ADDENDUM NO. 4

Date: **May 13, 2019**
Project: **Ltd. Renovations at Police Annex**
Contract No. P-18-001
3204 Amnicola Highway
Chattanooga, Tennessee 37406

Architect: **Billingsley/Architecture**
Suite 800 Republic Centre
633 Chestnut Street
Chattanooga, Tennessee 37450
(423) 752-0030

A2.1

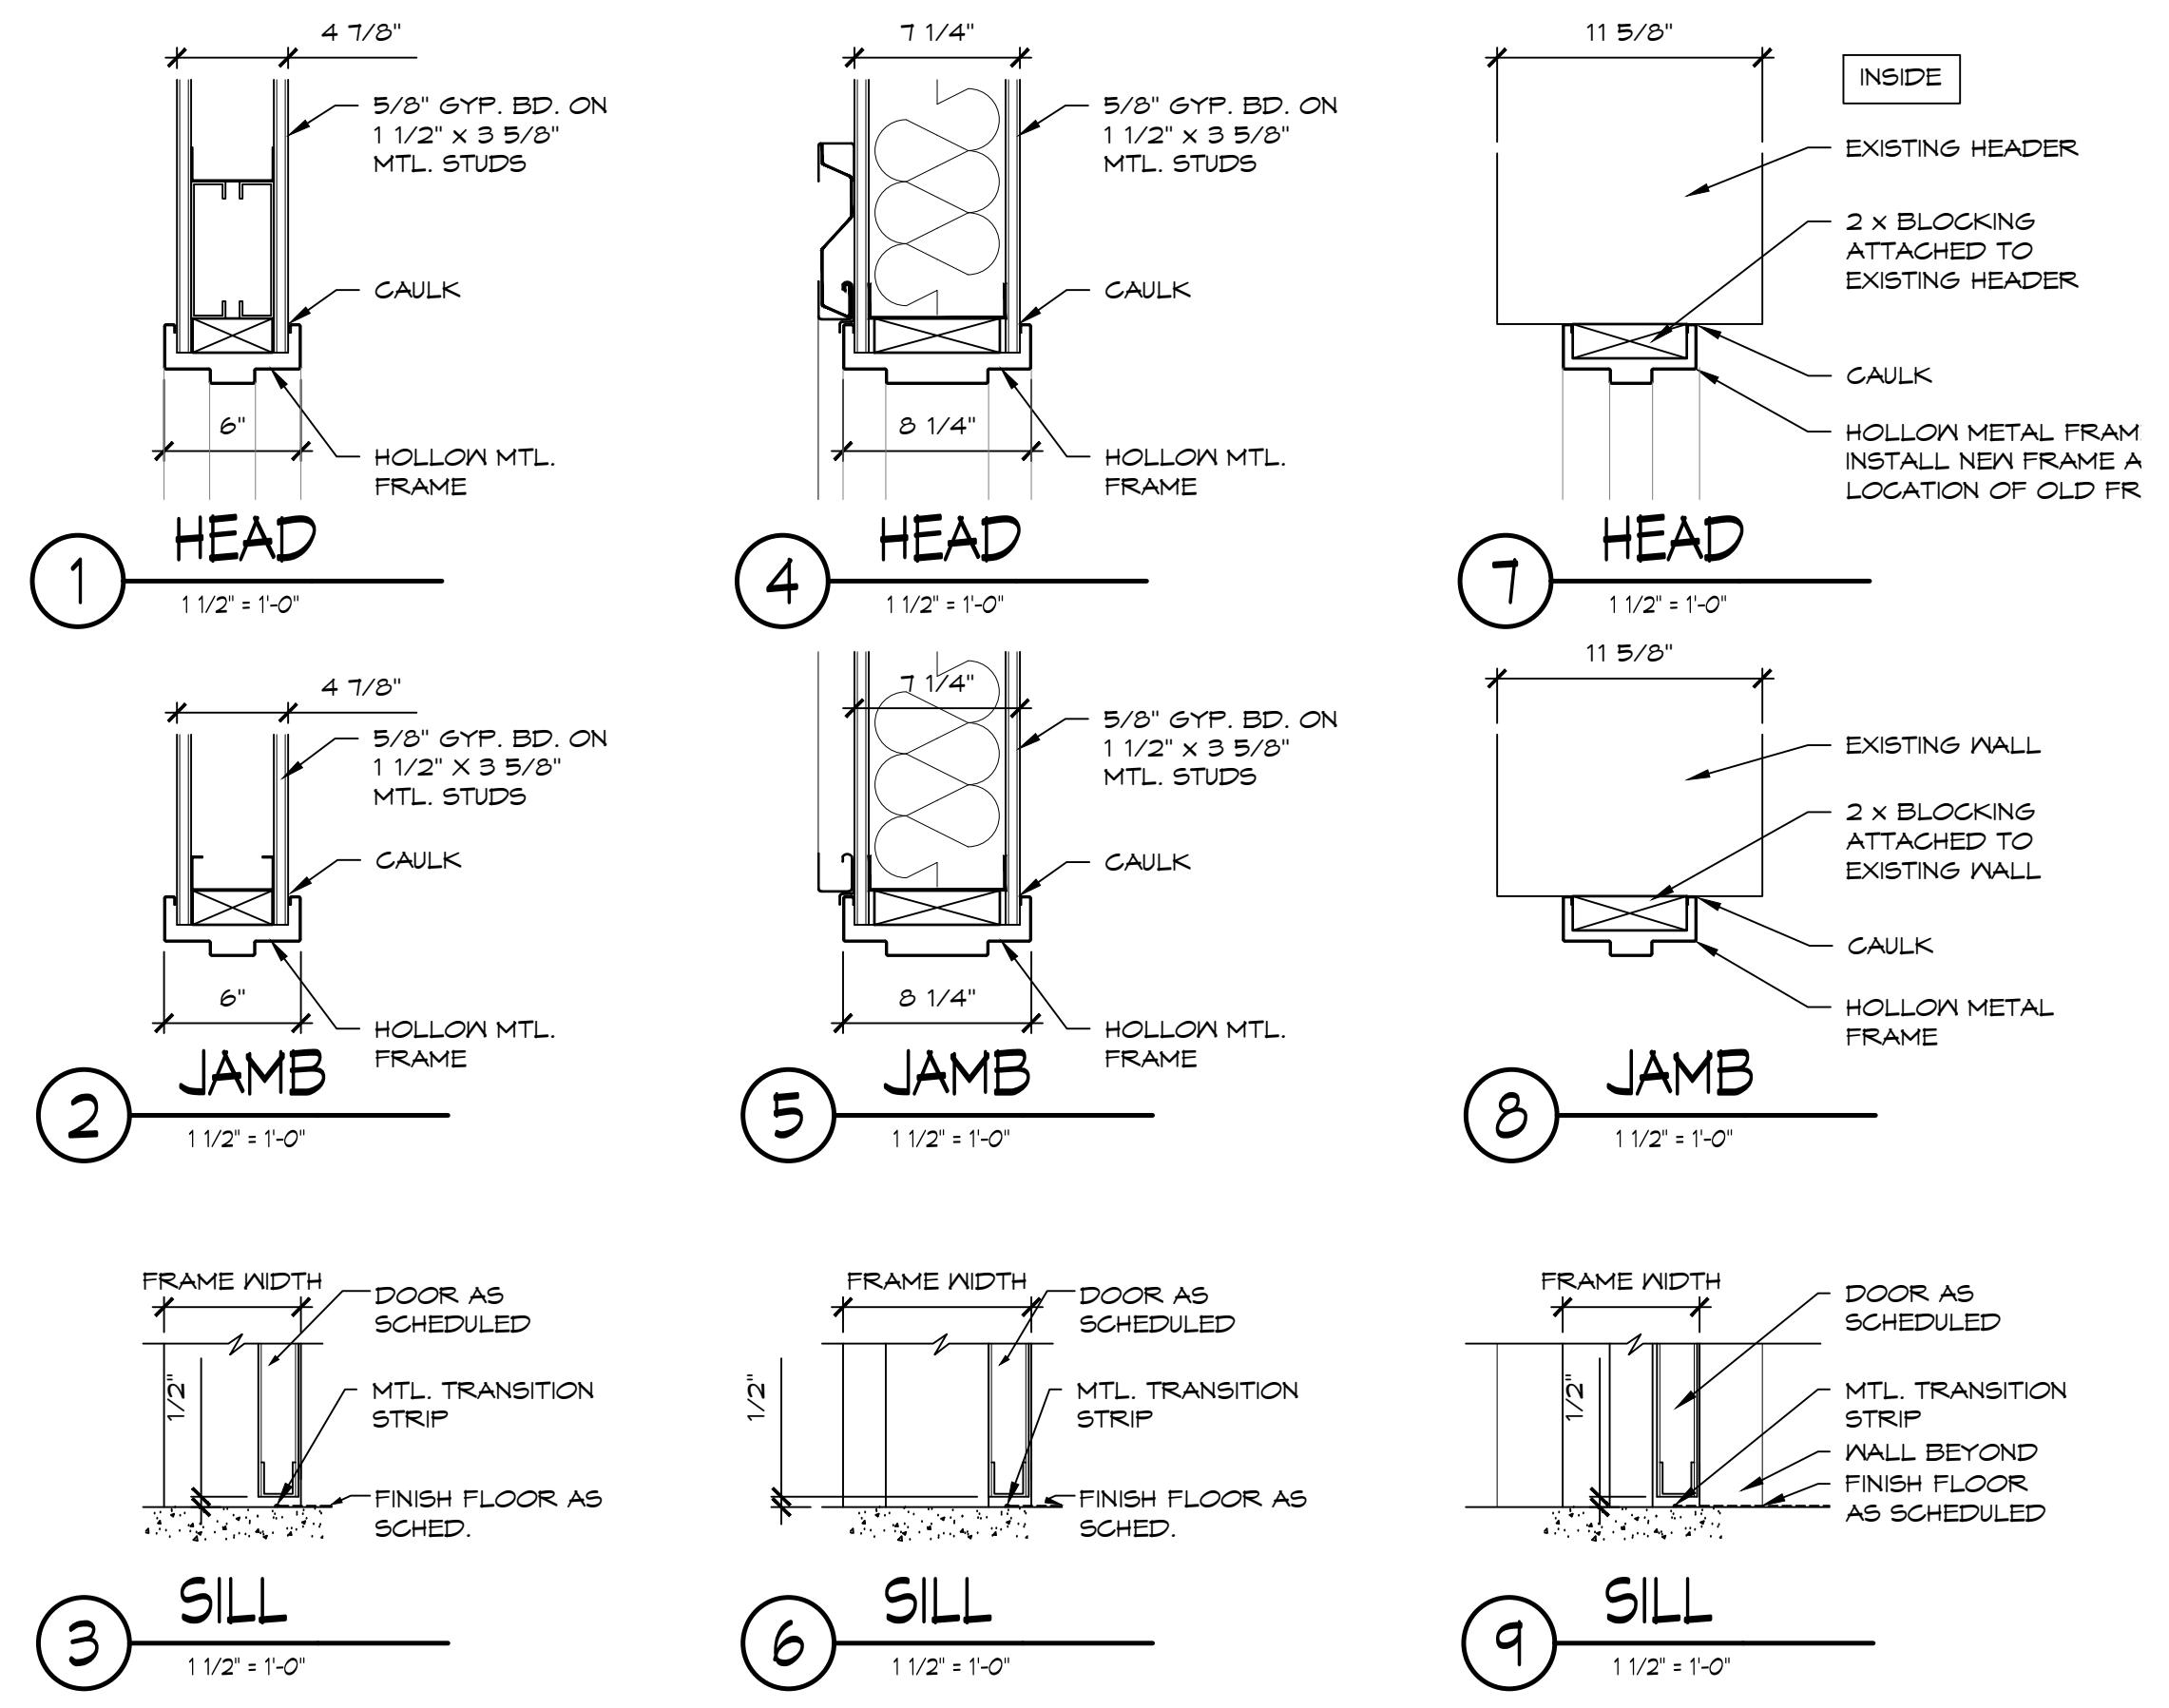
2. Sheet A2.1 First Floor Plan
 - B. Addition
 - c. Add new emergency generator.

2 ENLARGED PLAN @ STAIR 115
 3/4"x1'-0"

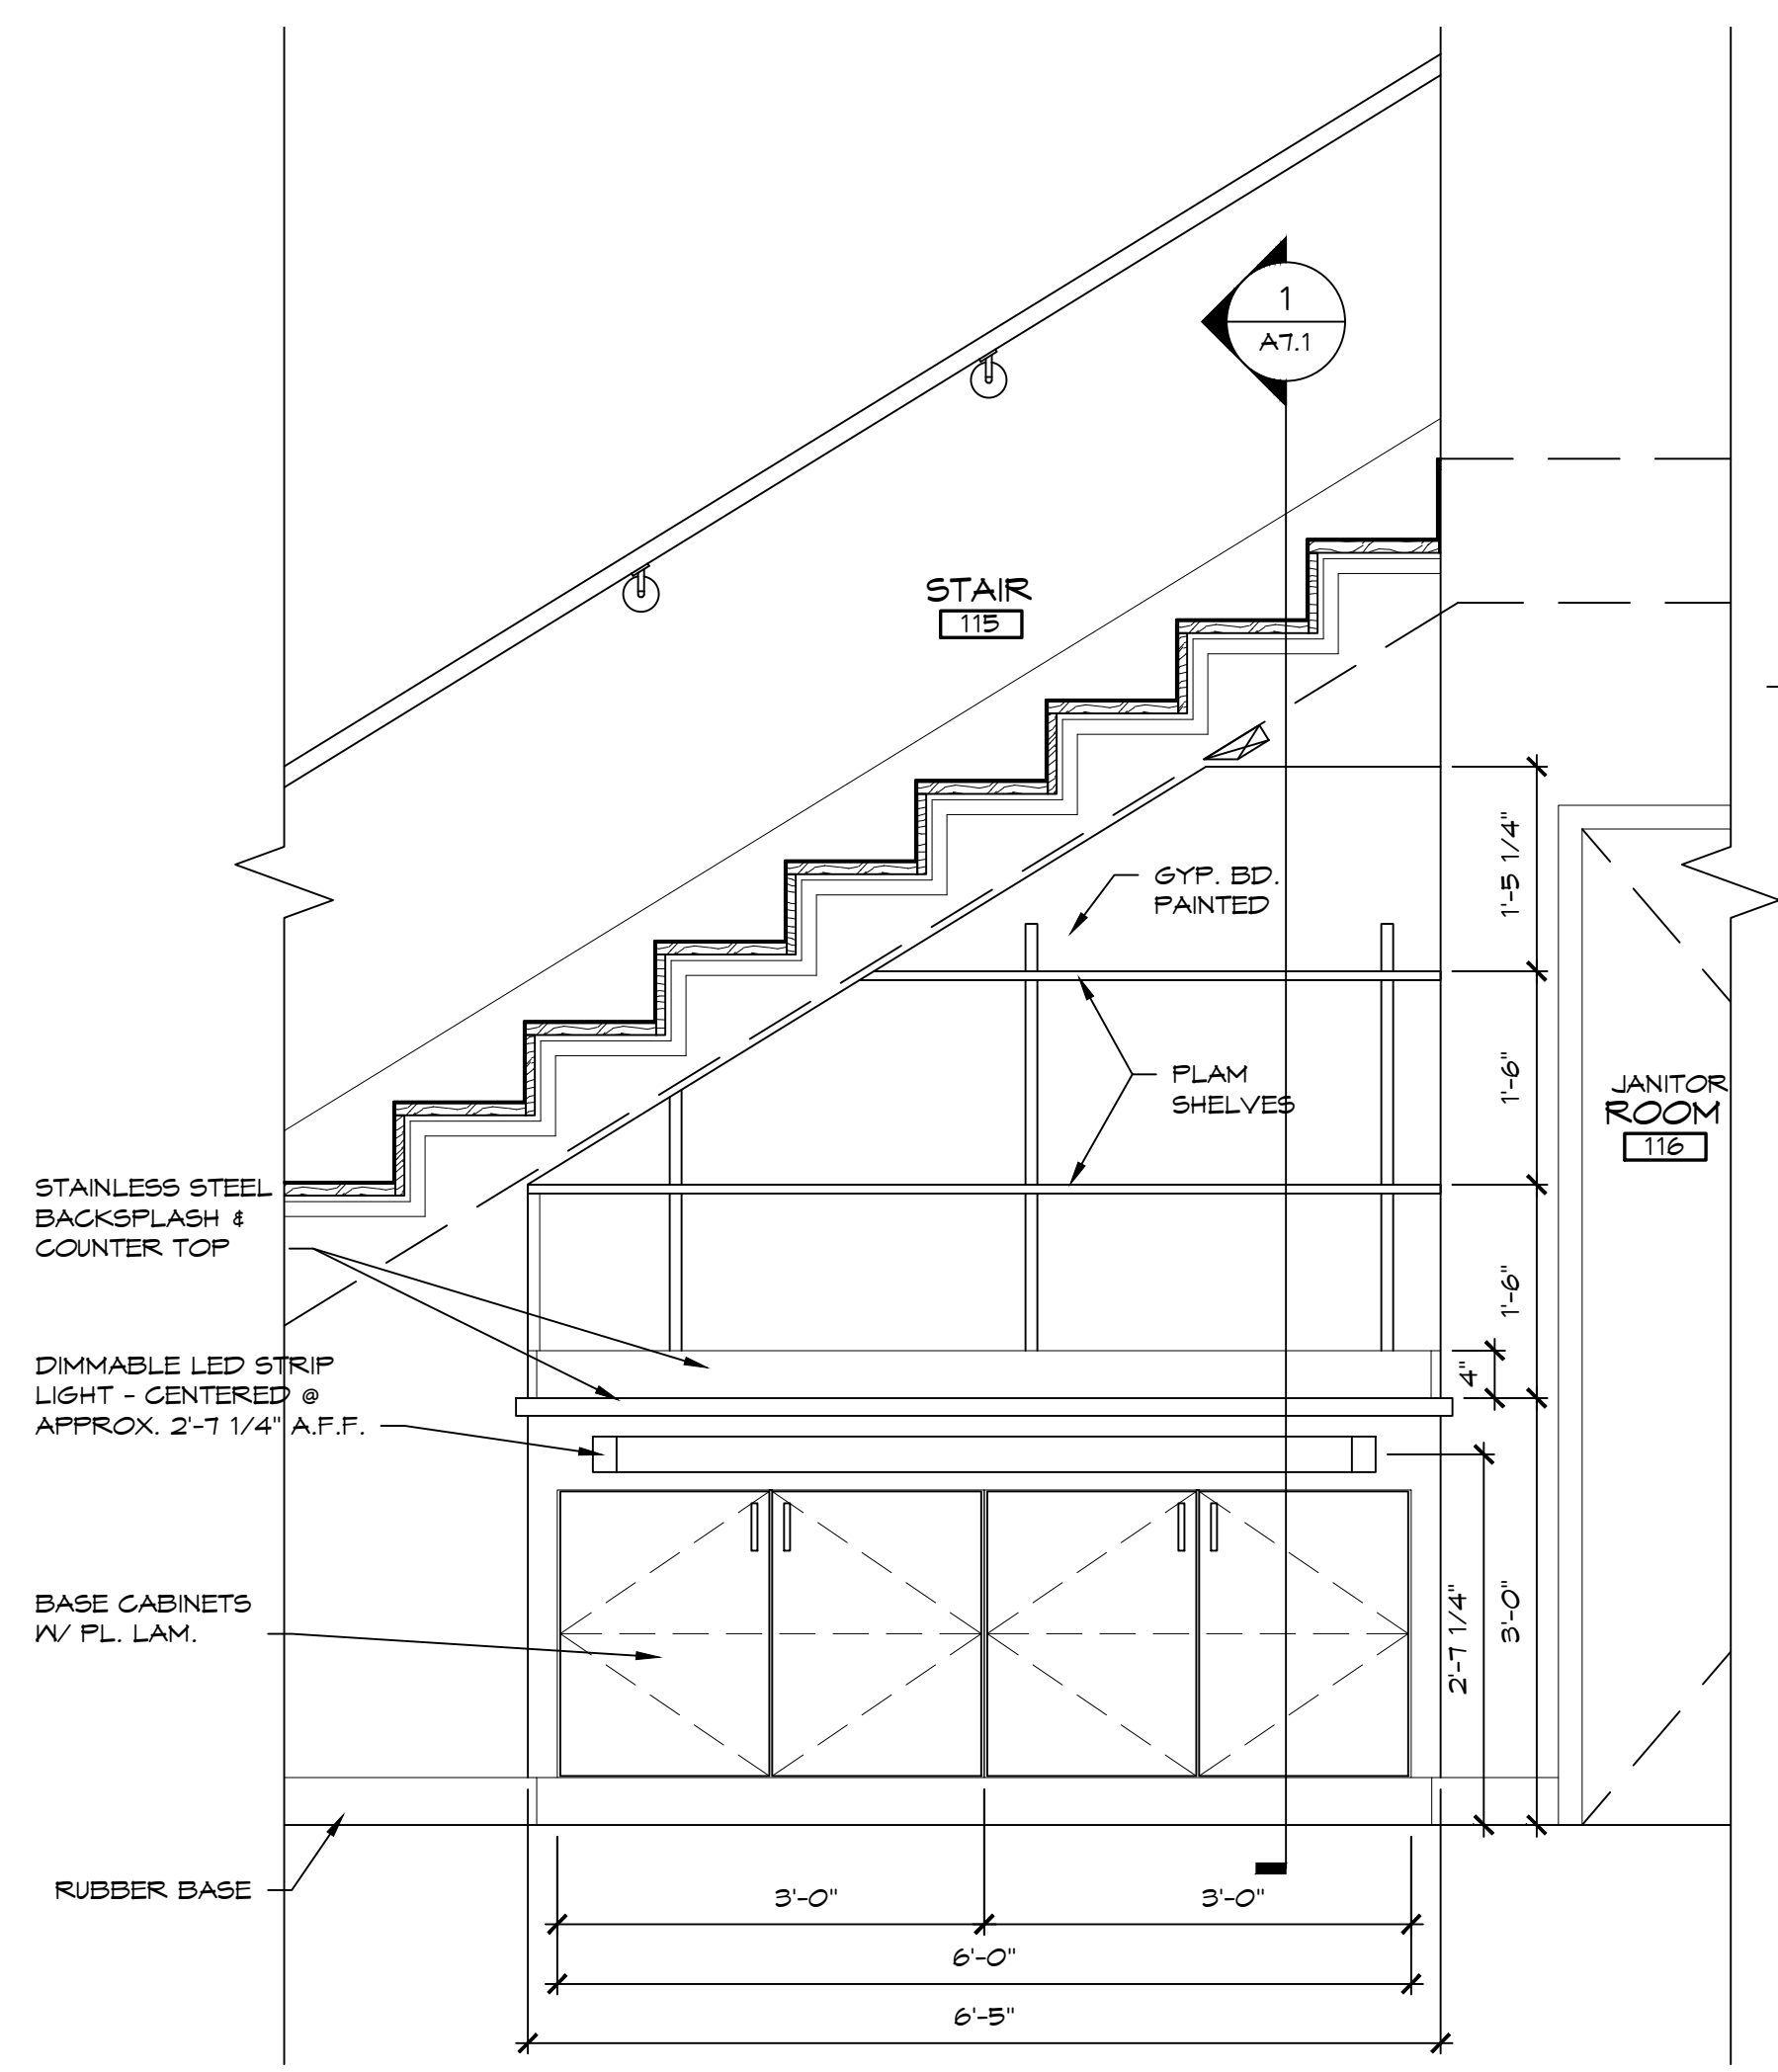
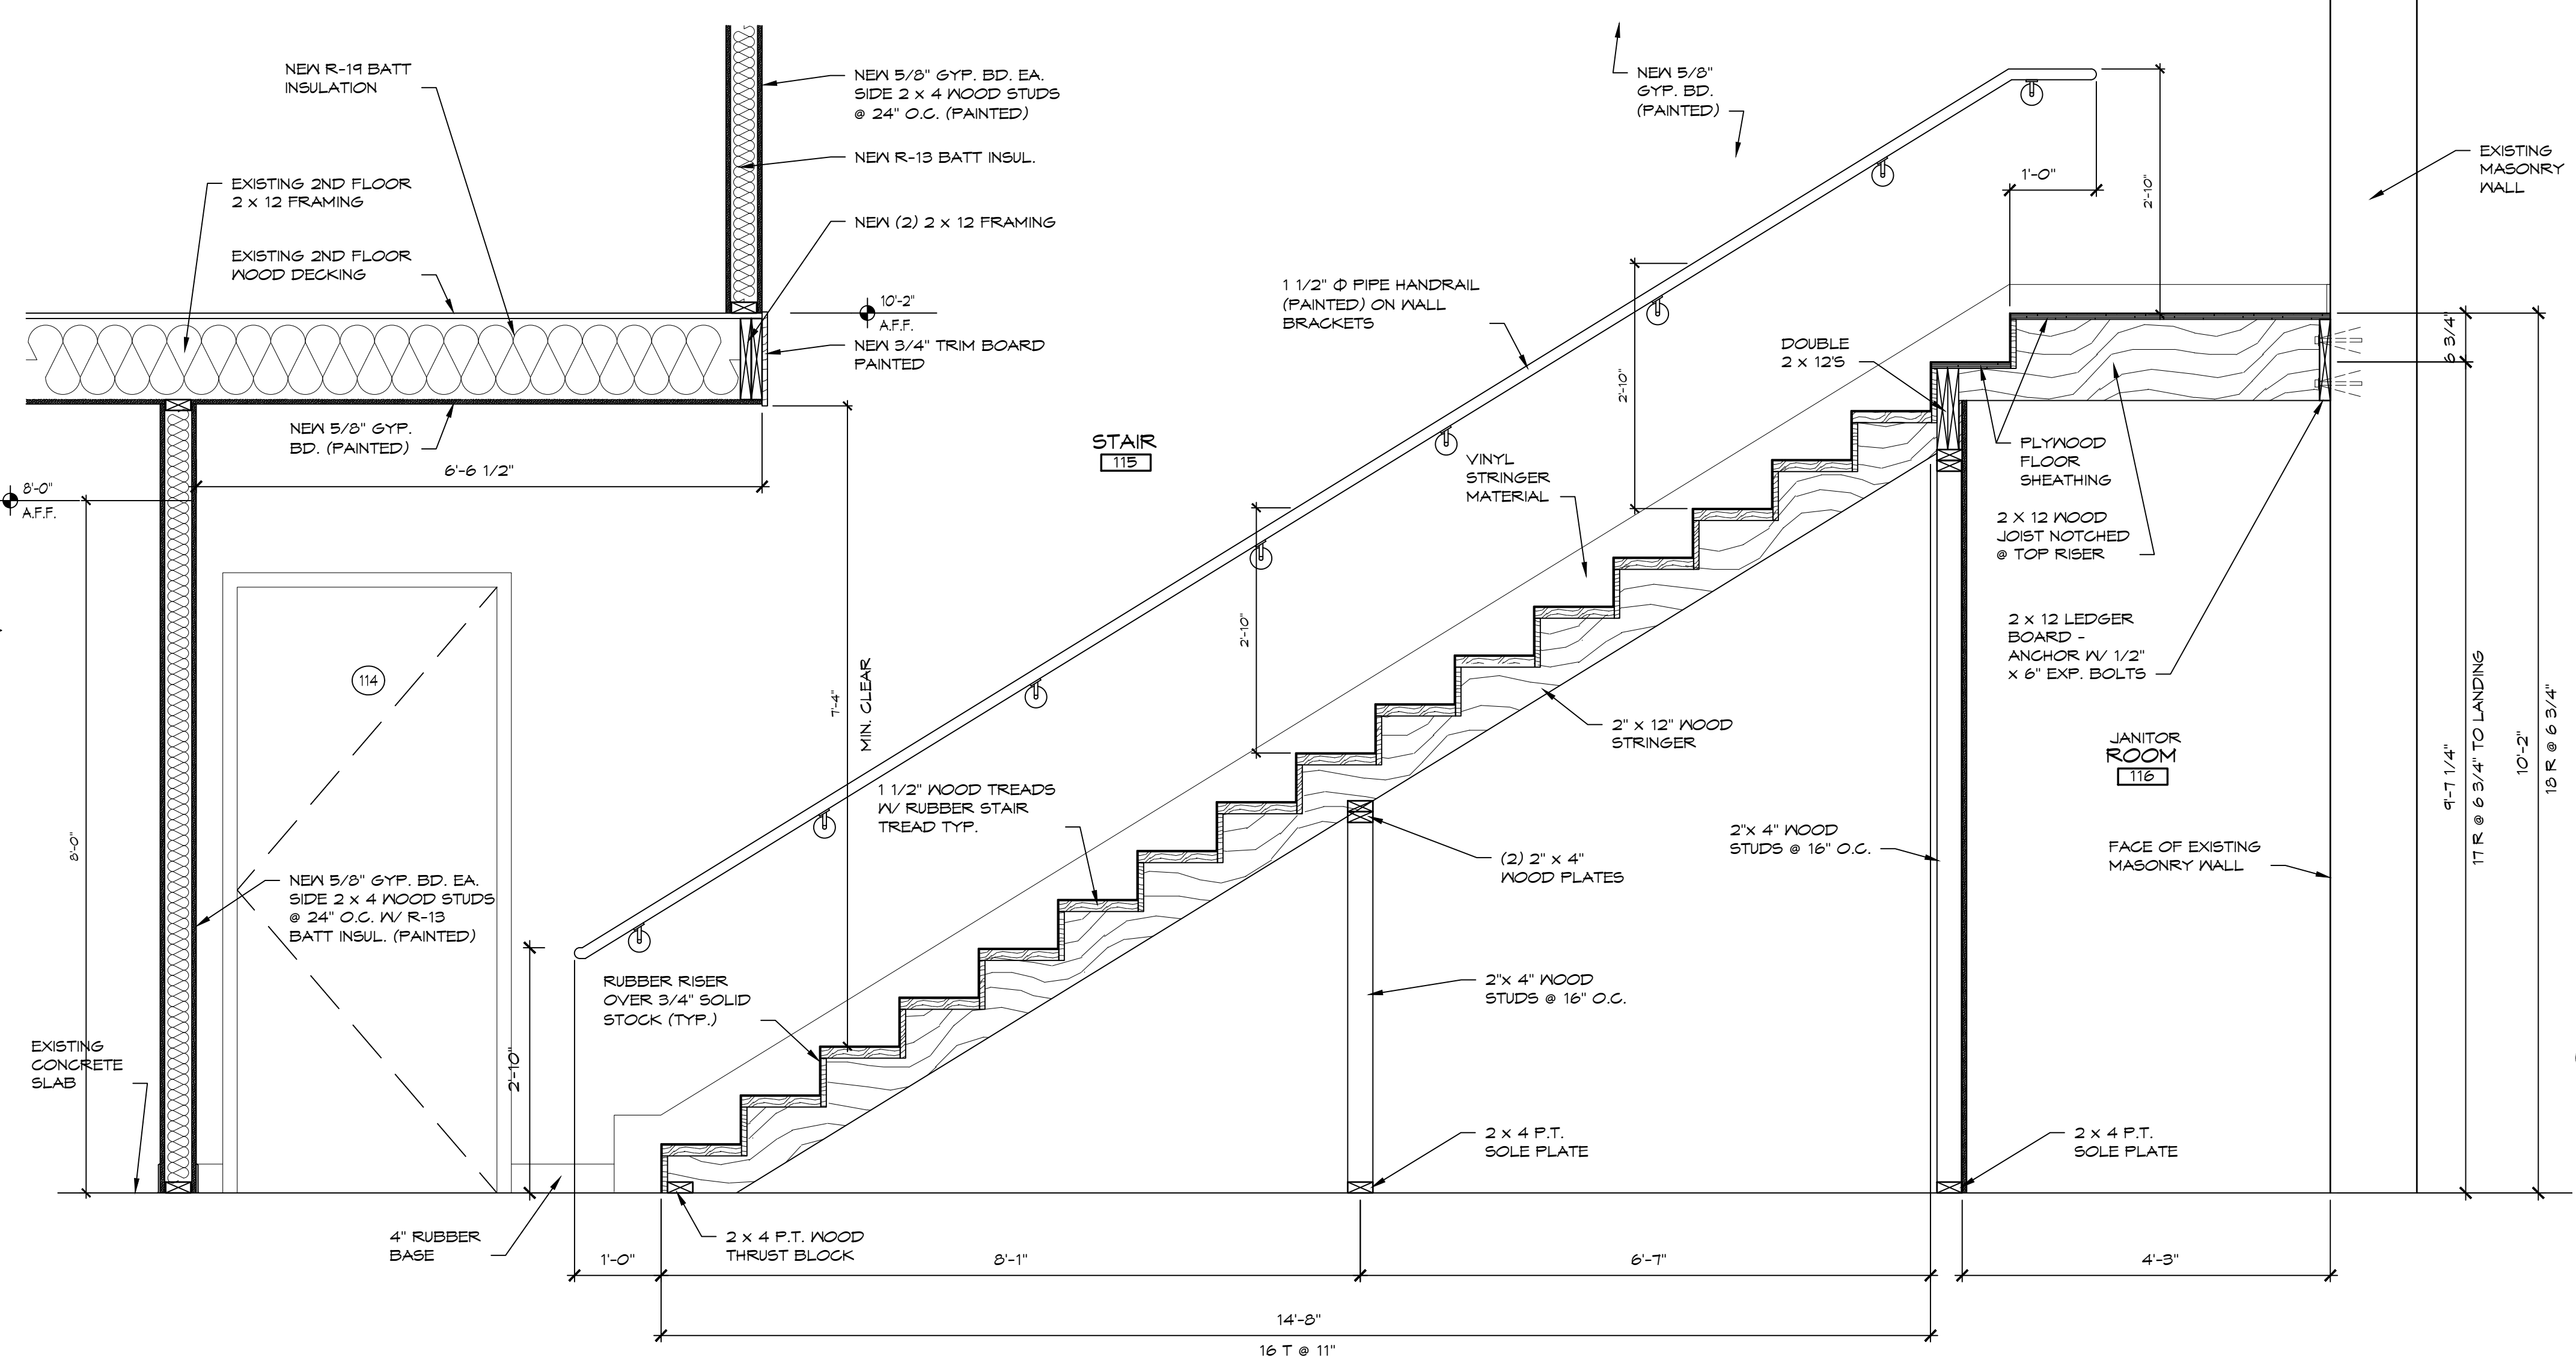
4. Sheet A7.1 Stair Details
 - D. Change
 - e. Change door swing direction at door #201.
 - f. Add label at door #201.
